DOCUMENTATION TRANSMITTAL

Documentation Description: Nonconformance Reports - C-00960 & C-02005-HV

NONCONFORMANCE REPORT

NONCONFORMANCE REPORT

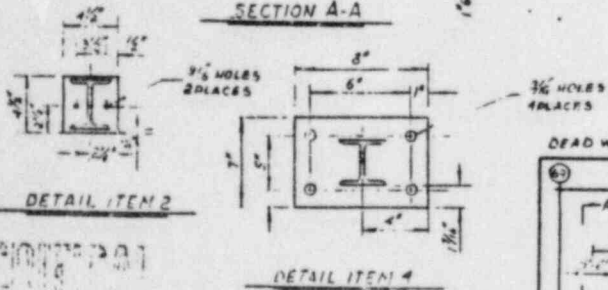
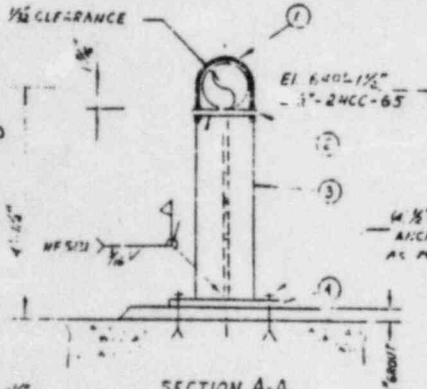
- 3) PCI P.2.30 B.3.10.1 (M-326 5.16.1) VERIFY THE SUPPORT MEMBERS ARE FREE FROM DAMAGE SUCH AS SURFACE DEPRESSIONS OR IMPERFECTIONS SHALL BE FREE OF CRACKS AND SHALL NOT IN FRINGE VAN THE MIN. MAT'L THICK. (B) $\frac{1}{16}$ " - THICK $\frac{3}{4}$ " - 2"
- 4) PCI P.2.30 B.3.12.15 (C-305 4.8) VERIFY THE MAXIMUM THREAD ENGAGEMENT LENGTH OF THE EXPANSION ANCHOR IS AT LEAST $\frac{1}{2}$ " SHORTER THAN THE MANUFACTURER'S SPECIFIED THREAD LENGTH TO ENSURE THAT THE NUT IS NOT BOTTOMED OUT.
- 5) PCI P.2.30 B.3.18.3 - U.T. REPORTS

- 3) SOUTH EAST ANCHOR BOLT HAS $2 \frac{1}{16}$ " GOUGE MARK.
- 4) BOLTS ~~APPEARED~~ TO HAVE BEEN CUT ^{OR GRINDED M 79 20 8-27-84} BEYOND THE CHAMFERED ENDS, MAKING THIS ACTIVITY INDETERMINATE.
- 5) U.T. REPORT NUMBERS 11842 AND 130582 HAVE DIFFERENT THICKNESS RECORDED ON THE TWO REPORTS. UT REPORT # 130582 CALLS FOR SOUTH WEST ANCHOR BOLT TO BE $6 \frac{3}{4}$ " LONG. ATTACH. 7 PAGE 1 DOES NOT IDENTIFY ANY $\frac{1}{2}$ " ANCHOR BOLTS TO BE THAT LENGTH.
